CALIFORNIA COASTAL COMMISSION

STAFF REPORT: APPEAL SUBSTANTIAL ISSUE

APPEAL NO.: A-4-CPN-03-016

PROJECT LOCATION: Corner of Carpinteria Avenue, Arbol Verde Street and Concha Loma Drive in the City of Carpinteria, Santa Barbara County.

Site Plan / Grading Plan
Scale: 1" = 10'

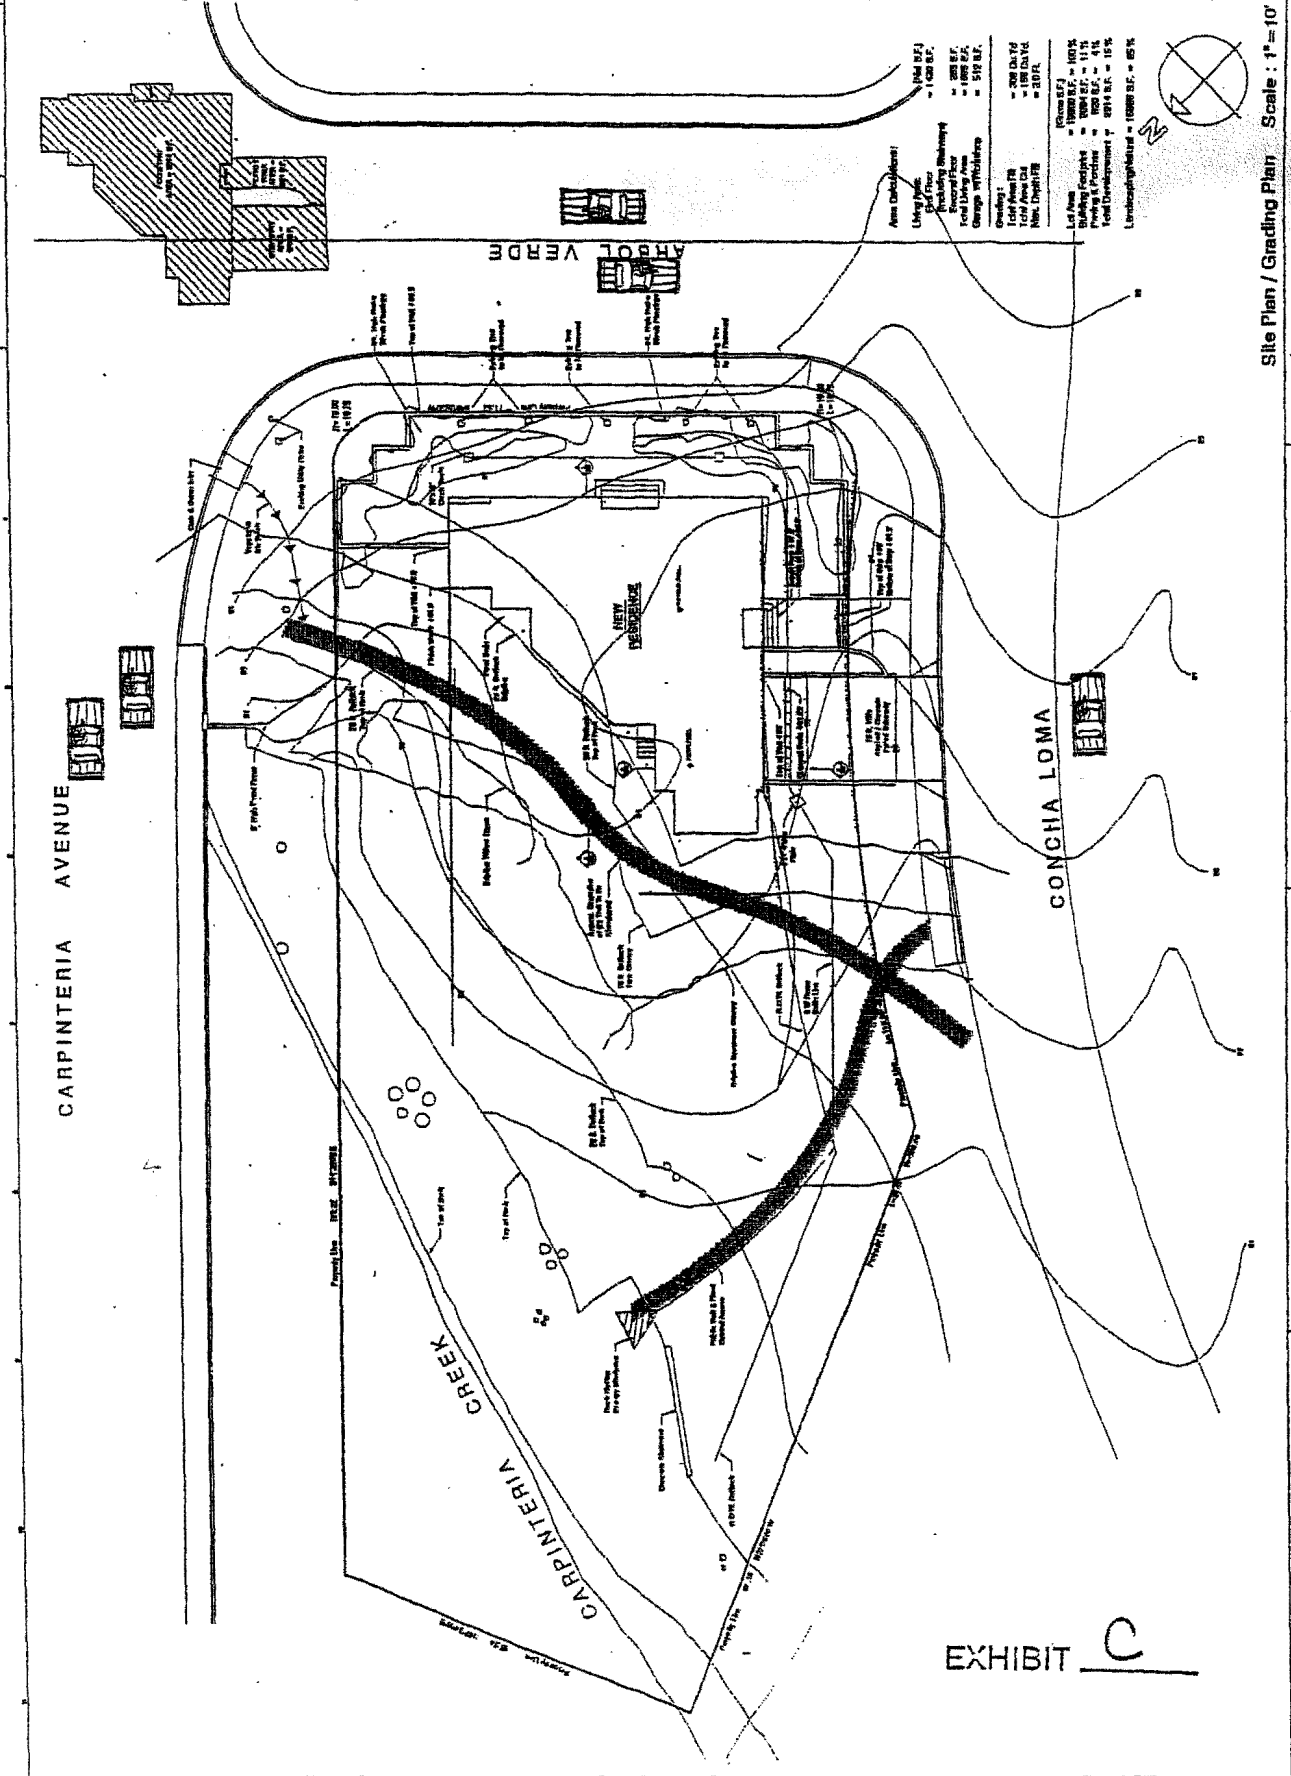
31. Prior to the issuance of a grading permit for the project, the proposed grading plan shall be revised to indicate that the temporary chain link construction fence is to be located along the "20-foot dripline" setback line that is depicted on the project's site plan/grading plan.

ESTIMATED VIEW BLOCKAGE FROM THREE PUBLIC AREAS BY
FILLING IN AREAS STAKED BY ARCHITECT

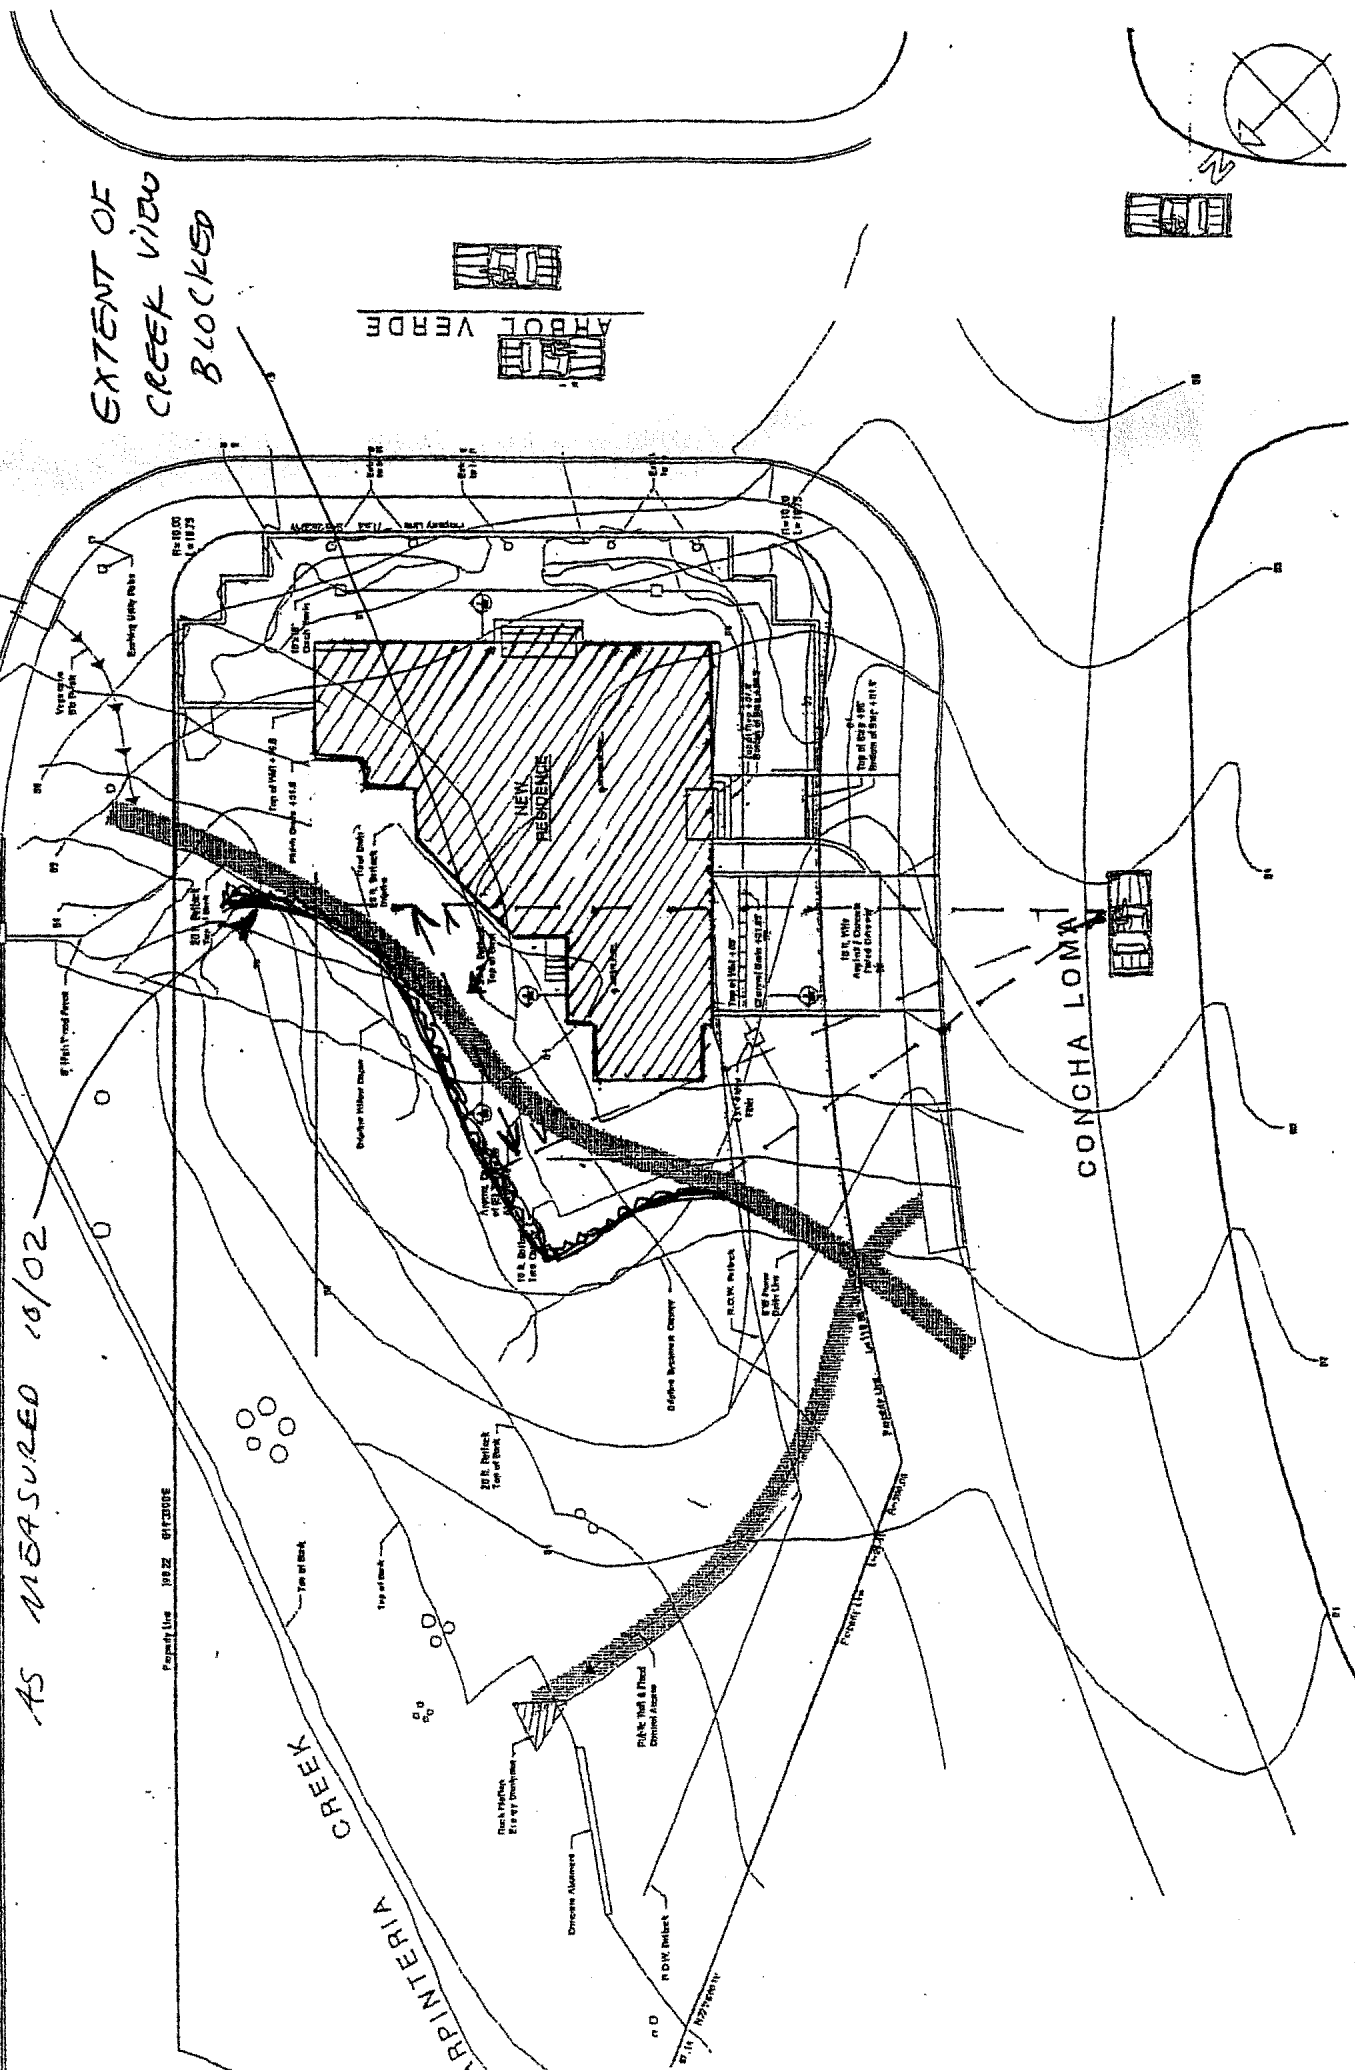
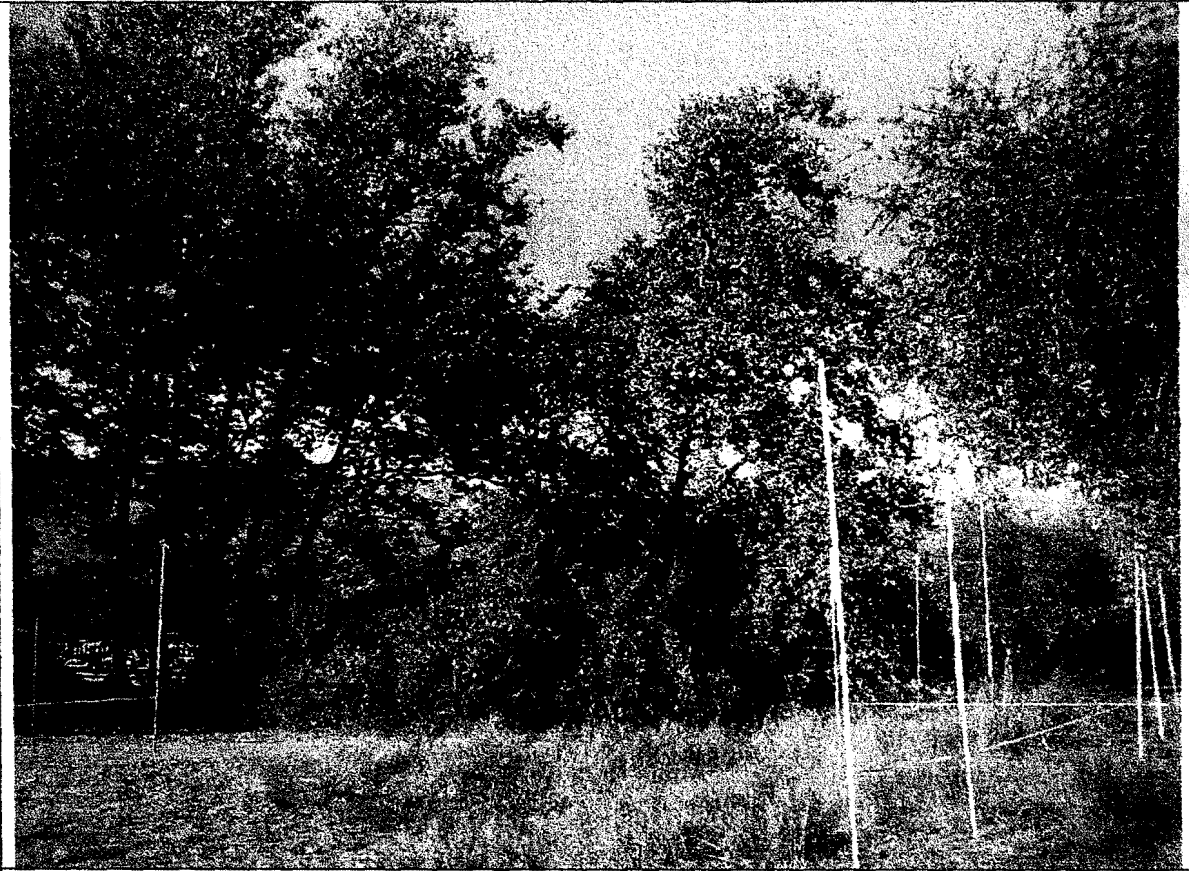
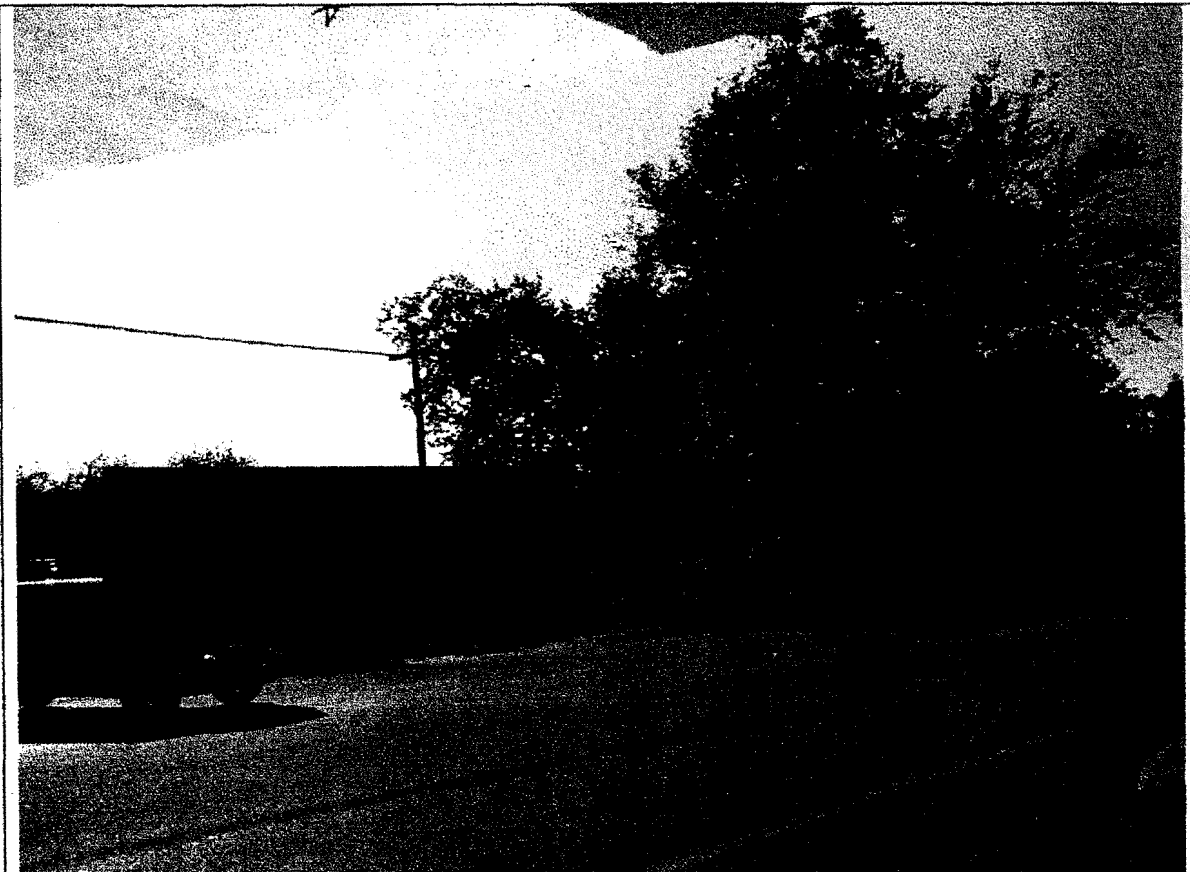
Though there is a proposal to mitigate view blockage with some creek restoration, I believe that the loss of the under story views is unmitigable. To restore the creek is an action that I strongly support but not at the cost of losing the aesthetics. Accurate graphic representations of the view blockage should be brought back before the Commission to aid in evaluating view blockage and for re-siting of the project to remove the substantial blockages, as is required under LCP Policy 4-1.
